PLAN COMMISSION MEETING

September 13, 2021
5:30 PM

To: Plan Commission
From: Kyle Kearns
Date: 09/07/2021

5) Landscaping

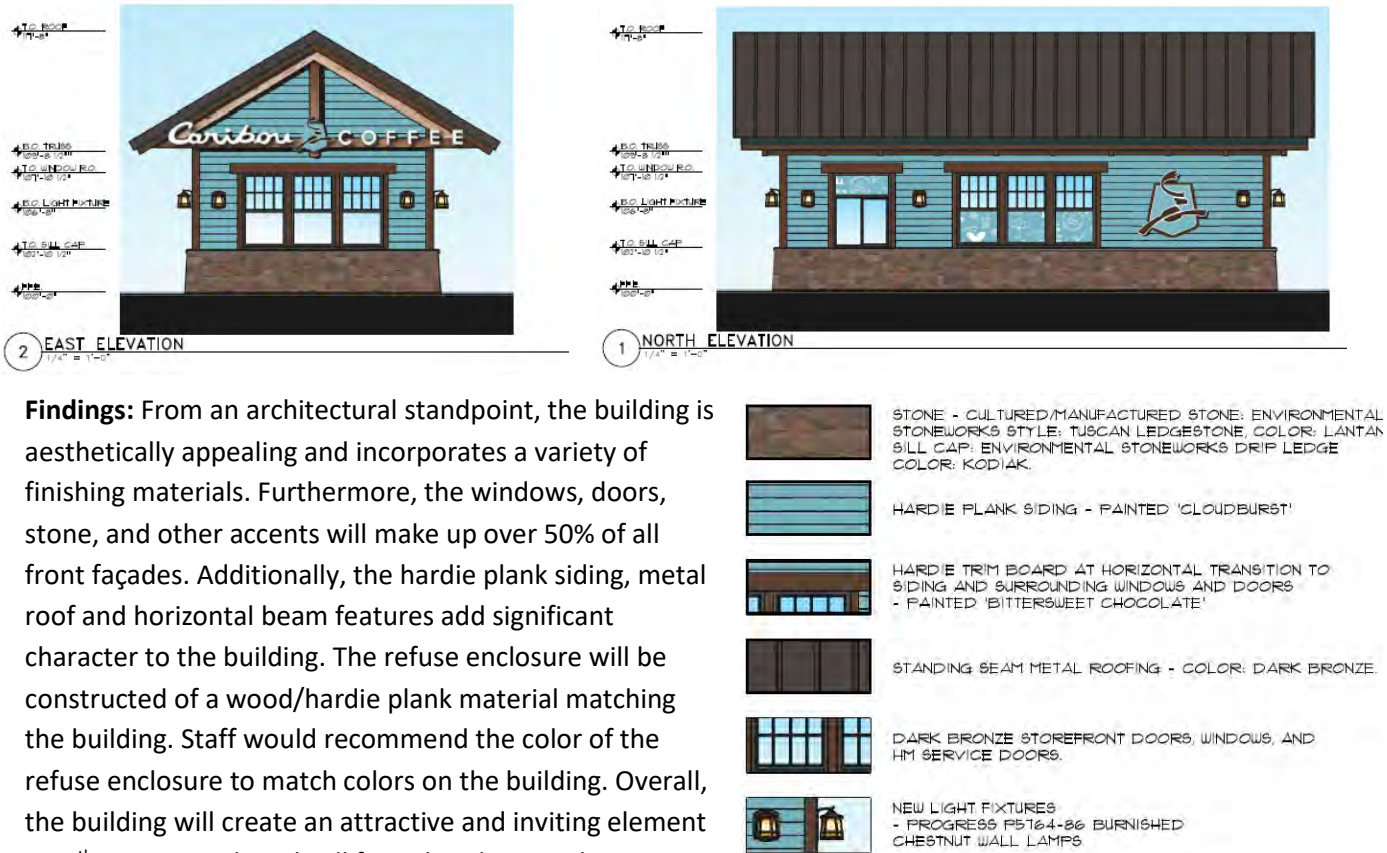
Findings: The site plan shows general landscaped areas around the driveway, parking, and drive-through which should be enough area (11,634 sq. ft.), 33% of the site, to meet the requirements. Upon review, a total of 255

street frontage landscape points are proposed, in the form of large and medium trees. Staff would recommend a detailed landscaping plan be provided meeting all applicable landscape requirements for the development, to be reviewed and approved by the Community Development Department.

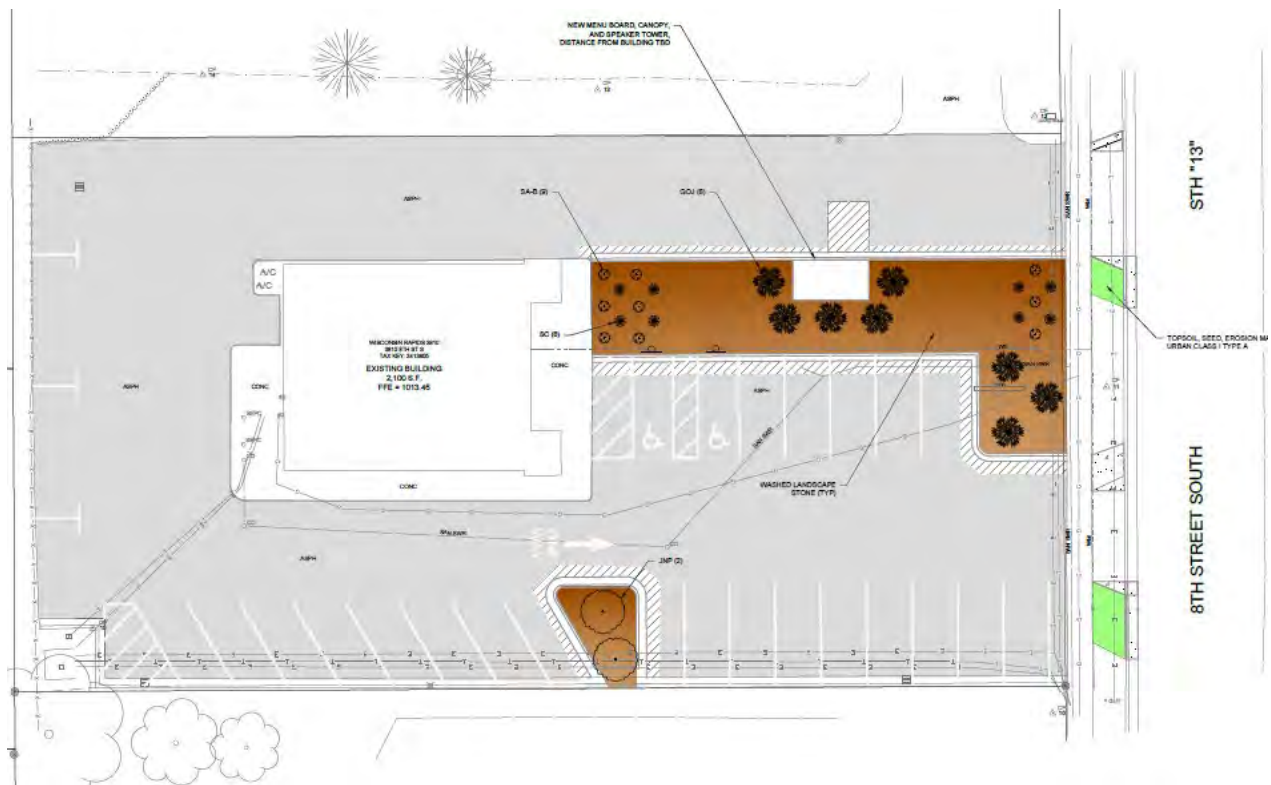
Findings: The development meets the parking requirements with 27 proposed stalls; however, 16 are found within the front of the building, which exceeds the 50% maximum requirement. Additionally, when more than

The above applicable standards are met on the proposed plan, but more than 50% of the parking exists within the front of the building. Staff would recommend approving a maximum of 50% of parking within the front of the building to be shown on an updated site plan to be reviewed and approved by the department.
